Recommended Modifications to the NRC White Paper:

Technical and Regulatory Basis: Interim Acceptance Criteria and Guidance for the Reactivity-Initiated Accident (Appendix 4B of NUREG-0800 Standard Review Plan).

Figure 1. Displaced sodium volume at an injected energy of 70 cal/gm as a function of test rod burnup for both MOX and UO₂ rods tested in the CABRI facility.

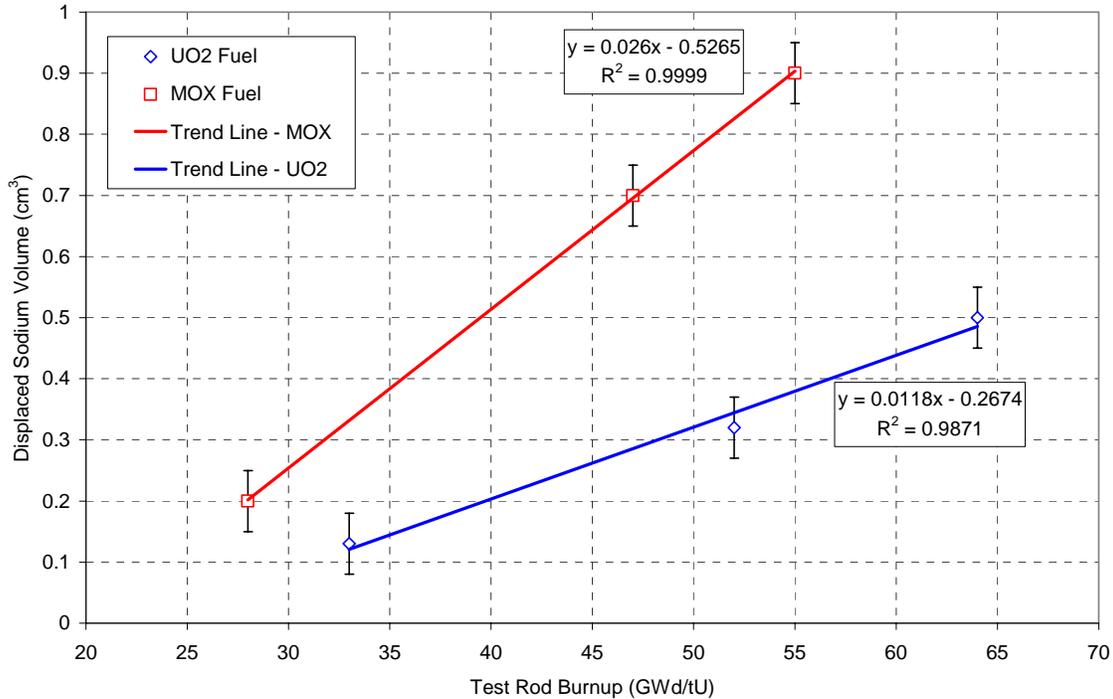
4. It is recommended that the MOX test CABRI REP Na-7 used in Figure 3.1-3 to define the PCMI fuel cladding failure criterion for PWR fuel be removed from consideration.

The MOX test CABRI REP Na-7 result in Figure 3.1-3 is not applicable to UO₂ fuel because the fuel enthalpy at failure in irradiated MOX rods is not representative of UO₂ rods. Consideration of REP Na-7 is the primary cause of the excessive reduction (lower than RIL 0401) in the values given for criterion #2 at oxide ratios near 0.8.

A review of the experimental data has shown that the pellet expansion process in irradiated MOX fuel is larger than for irradiated UO₂ fuel for a given radial average enthalpy level. The result is that the PCMI forces in MOX fuel produce a cladding strain that can be approximately twice that in UO₂ fuel for highly irradiated rods.

Experimental data from both the CABRI and NSRR RIA tests show that irradiated MOX fuel behavior is different from irradiated UO₂ fuel under RIA conditions at similar burnup and fuel enthalpy levels. Post-test ceramography examinations and measurements of cladding permanent hoop strain and fission gas release reported in the literature finds that irradiated MOX fuel experiences stronger pellet-cladding mechanical interaction (PCMI), larger amount of pellet swelling, and higher fission gas release during rapid energy deposition events as compared to UO₂ fuel. These post-test observations are supported by in-pile measurements of dynamic fuel rod volume changes during the CABRI experiments.

An important indication of the enhanced PCMI due to pellet swelling in the MOX rods comes from the dynamic rod volume changes measured in the CABRI reactor. The effect of MOX pellets on the fuel rod expansion process is shown clearly in Figure 1 which contains a plot of the displaced sodium volume from the flow channel at an injected energy of 70 cal/gm as a function of test rod burnup in the UO₂ and MOX rods tested in CABRI. The amount of sodium displaced from the flow channel is determined by integrating the difference between the channel outlet and inlet flowmeter measurements. The sodium expelled from the flow channel consists of two parts; the prompt part caused by fuel rod volume expansion and the delayed part caused by sodium dilation. The sodium volume displacement from the flow channel that is of interest is that caused by the radial and axial expansion of the test rod during the early energy deposition phase of the RIA tests in CABRI. Early time measurements of the displaced sodium volume represent mostly the fuel rod volume change due to PCMI. In the later portion of the transient, rod to coolant heat conduction causes dilation of the sodium, leading to a further increase in displaced sodium volume beyond that caused by PCMI. The results shown in Figure 1 are at an injected energy of 70 cal/gm, which is early enough in the power pulse for the different tests to minimize the effect of rod to coolant heat conduction on sodium dilation and clearly show the effect of fuel rod expansion due to PCMI.

In general, both UO₂ and MOX fuel rods show a tendency of larger fuel rod expansion with an increase in burnup. Such behavior is caused by the progressively smaller residual pellet-cladding gap from fuel swelling and cladding creep during the base irradiation for the higher burnup rods. More importantly, the measured values shown in Figure 1 demonstrate that the fuel rod volume increases at a faster rate in the highly irradiated MOX rods as compared to the UO₂ rods during the energy deposition phase of the experiments. For the UO₂ rods, the displaced sodium volume results shown in Figure 1 reflect the amount of fuel rod volume change caused by thermal expansion of the UO₂ pellet column. This has been confirmed by analysis. Such is not the case for the MOX rods, where the increase in fuel rod volume is much higher than expected based only on pellet thermal expansion. From the linear trend of the data shown in Figure 1, the effect of burnup on the fuel rod expansion rate is about 2 times higher in MOX fuel than a UO₂ fuel. The larger pellet expansion process in MOX fuel pellets increases the PCMI forces on the cladding, thus increasing cladding deformations in MOX fuel rods. As a result, the failure of CABRI REP Na-7 at a radial average peak fuel enthalpy of 113 cal/gm does not represent a UO₂ fuel rod at the same fuel enthalpy. Based on this assessment, a separate failure threshold is required for MOX fuel that accounts for the increase in PCMI forces as burnup increases.

Figure 2. Definition of time of maximum prompt fuel enthalpy rise

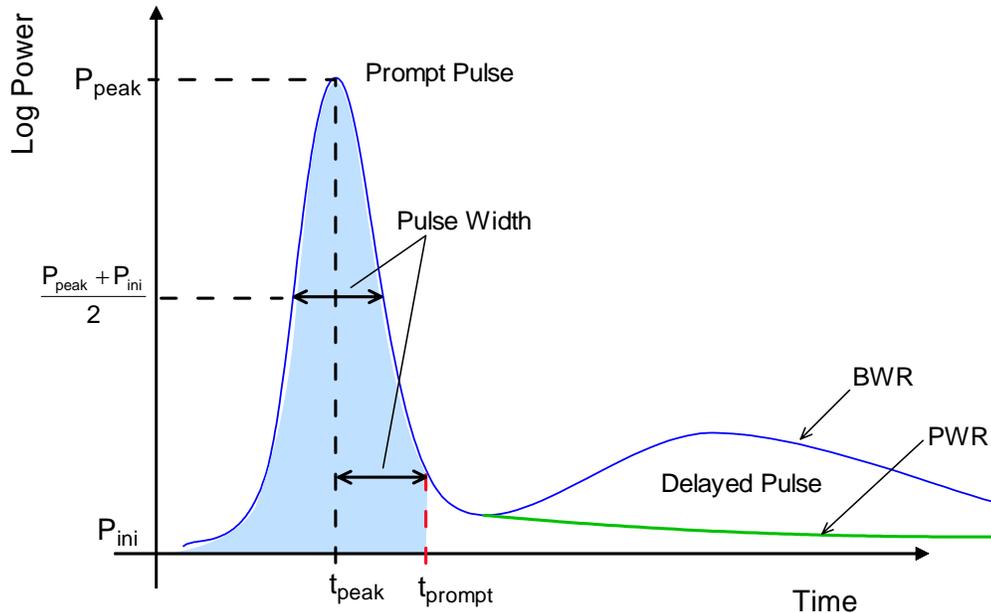
8. It is recommended that the fuel enthalpy rise in failure criterion #2 for PCMI failure shown in Figures 3.1-3 and 3.1-7 be changed to the prompt fuel enthalpy rise and that the use of failure criterion #2 be restricted to the prompt fuel enthalpy rise for both BWRs and PWRs. The prompt fuel enthalpy rise is defined as the radial average fuel enthalpy rise at the time corresponding to one pulse with after the peak of the prompt pulse as shown in Figure 2. Failure criterion #1 for non-PCMI failure should be applied to the total fuel enthalpy (prompt + delayed) to evaluate failure by non-PCMI processes.

Because of the power pulse characteristics of both the BWR control rod drop accident and the PWR control rod ejection accident, the fuel enthalpy rise consists of two parts; (1) the prompt part during which limited clad heating occurs, and (2) the delayed part during which significant clad heating has occurred. The total fuel enthalpy rise is the sum of the two parts. Cladding failure by PCMI is only possible during the prompt part of the power pulse when the pellet thermal expansion rate exceeds the heat conduction rate across the pellet-cladding

gap to the cladding. During the later delayed part of the fuel enthalpy rise, significant clad heating occurs with a corresponding improvement in material ductility, which precludes failure by PCMI. Failure by high temperature processes (ballooning/burst or oxidation embrittlement) is still possible during the delayed fuel enthalpy rise, depending on the maximum cladding temperature and the pressure differential across the cladding. In a commercial LWR, the prompt part of the fuel enthalpy rise is 70% to 90% of the total enthalpy rise. In developing a failure criterion for PCMI, the enthalpy rise to failure from the PCMI-related failures in NSRR and CABRI only applies to the prompt part of the total enthalpy rise.
